# Memorandum

**SUBJECT: TRAFFIC SIGNAL MODIFICATION AT WINCHESTER BOULEVARD AND FOREST AVENUE**

**SUBJECT: DRAFT EIR FOR THE 90 N. WINCHESTER DEVELOPMENT PROJECT  
(SANTA CLARA GARDENS)(File No. OA06-001)**

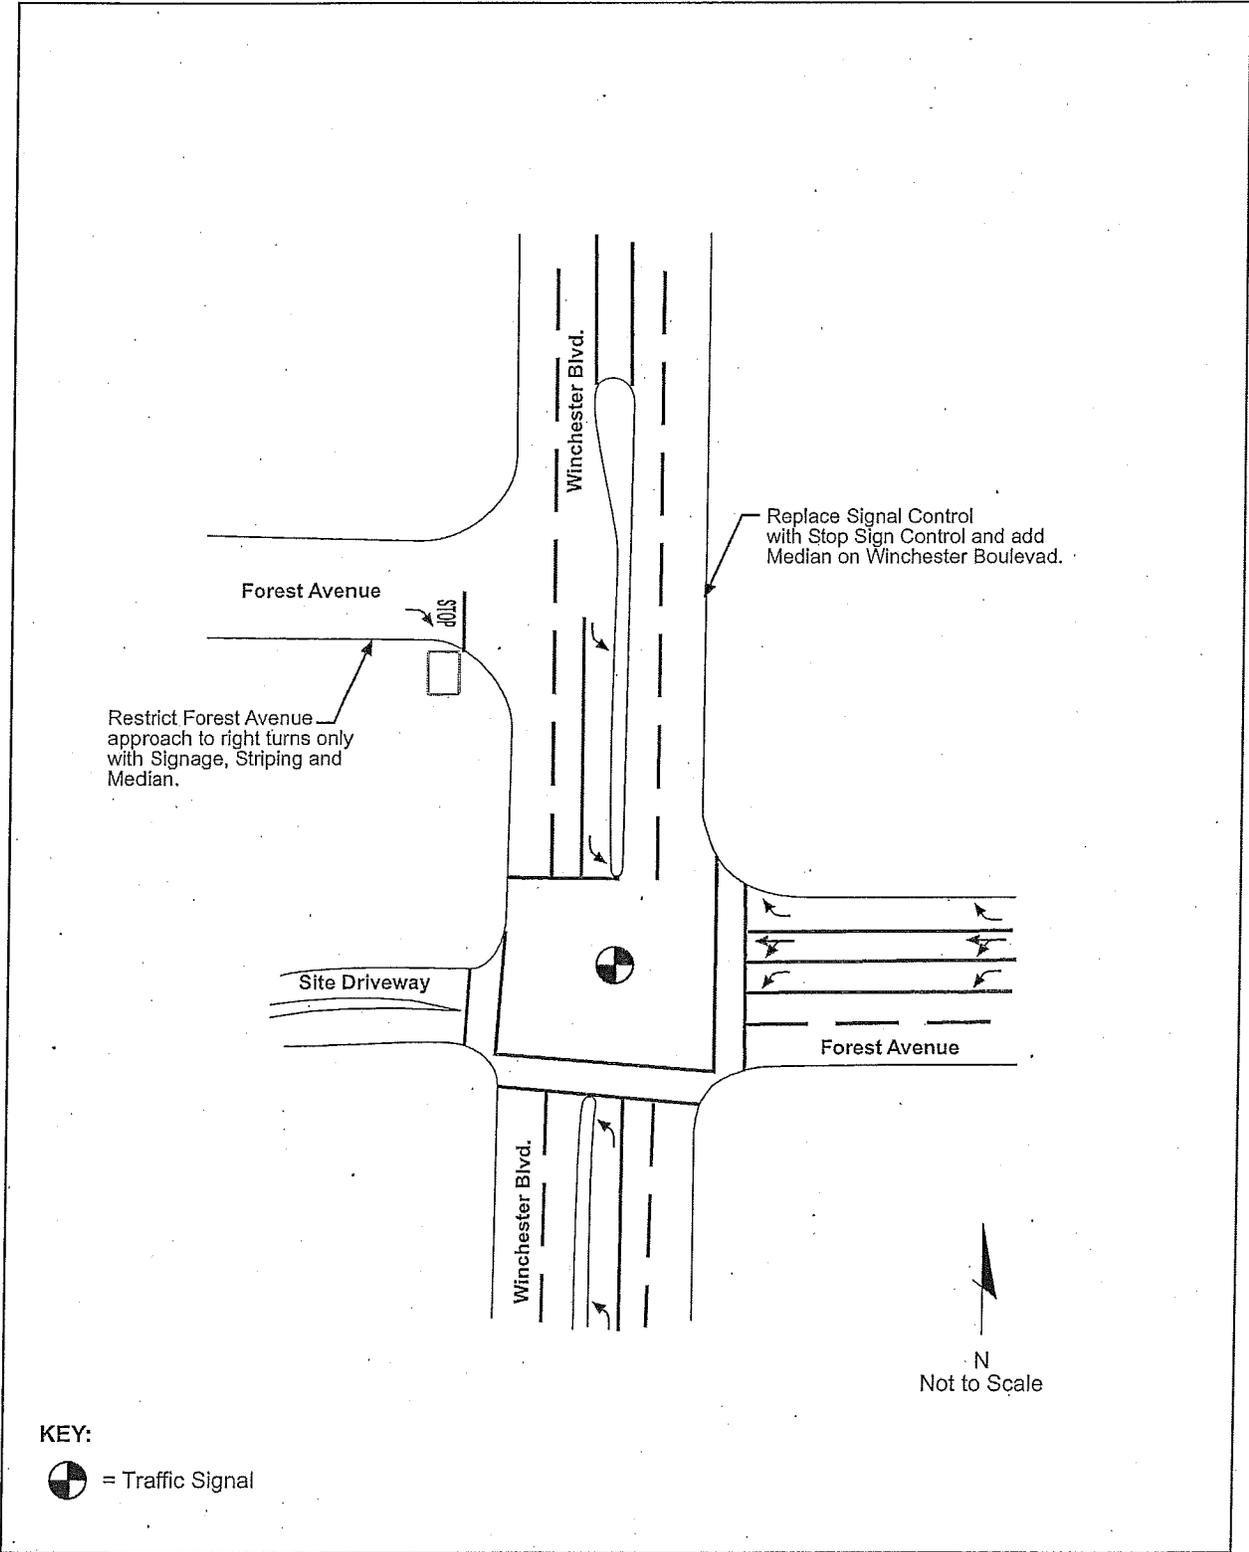
Option 1) The access configuration Exhibit 4-11a labeled "New site driveway with existing access" would not be acceptable because of potential operational and safety conflicts with the existing Forest Ave. neighborhood's signalized access west of Winchester Blvd.

Option 2) Furthermore, the solution proposed in the report, illustrated in Exhibit 4-11a labeled "New site driveway with modified Forest Ave. access" which includes removal of the signalized access to the existing Forest Ave. neighborhood west of Winchester Blvd, appears acceptable from an engineering perspective, but causes neighborhood impact or livability impacts to the existing Forest Ave. neighborhood which may cause the City of San Jose to ultimately reject the proposed improvement.

Therefore, the City of San Jose is not prepared to commit to approving the recommended new site driveway with modified Forest Avenue access without input from the affected San Jose residents westerly of Winchester Blvd. who would lose the signalized access and concurrence from the San Jose City Council District 6 Office, which represents those residents. The proposed signal modification appears to primarily benefit the Santa Clara Gardens Development Project in the City of Santa Clara at the expense of City of San Jose residents' existing access to Winchester Blvd, at Forest Ave. The report should analyze other design options, should the affected San Jose neighborhood and City Council District 6 Office not concur with the modification, such as construction of a right-turn in/out only driveway or relocating the main project driveway outside of the operations of the current offset Forest Ave./Winchester Blvd intersection.
